Clarification of the Compatibility between the Vehicles and the CRSs, and Japan's concerns

52nd GRSP Informal Group on Child Restraint System

18th Jun. 2015

JASIC

Table of the compatibility between the vehicle and the Universal booster seat or the Lateral facing i-size(?) CRS (under consideration)

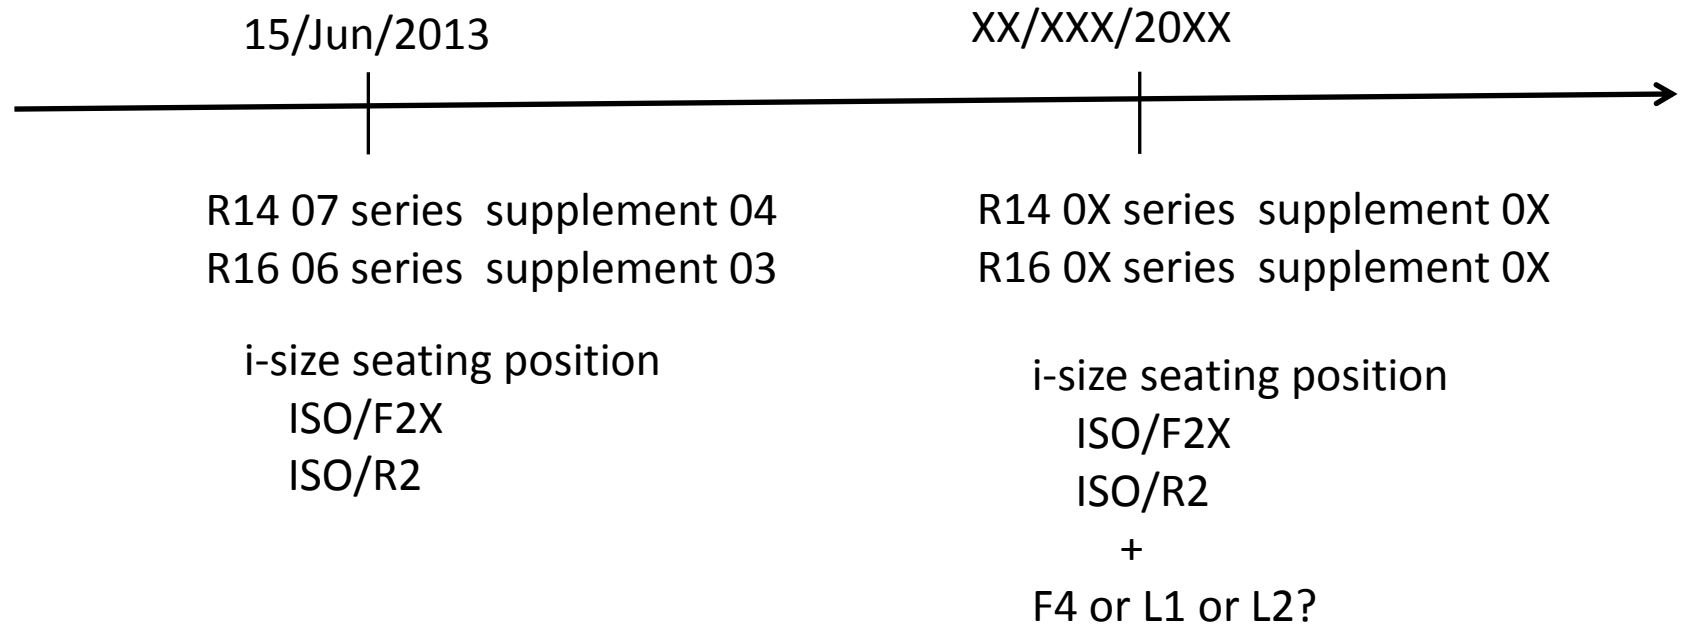
D : Checked in the case of boosters whose size is F4 or below

E : The mark of the Universal booster seating position not necessary?

F : “i-size” or “i-size compatible “or other?

If “i-size compatible” or other, how should it be defined?

Concern about “i-Size seating position”

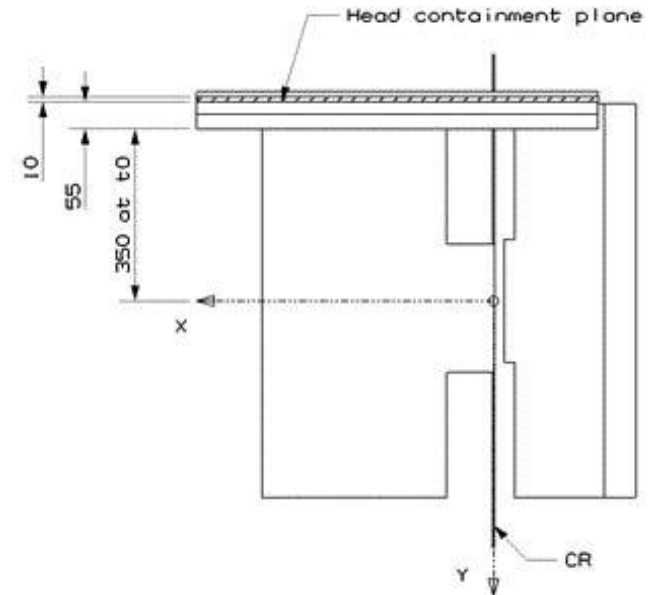
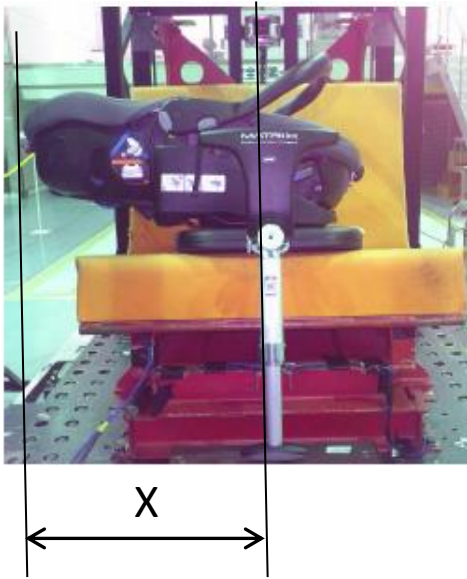
As regards the current i-Size seating position, the installation of ISO/F2X and ISO/R2 fixtures is checked, after 15th/June/2013.

If the R14 and R16 will be amended that the installation of ISO/F2X, ISO/R2 and “F4 or L1 or L2” fixtures will be checked for the i-Size seating position, the cases that the same “i-Size seating position” is used as though the checked fixture sizes are different, will be occurred.

This is likely to cause confusion to consumers.
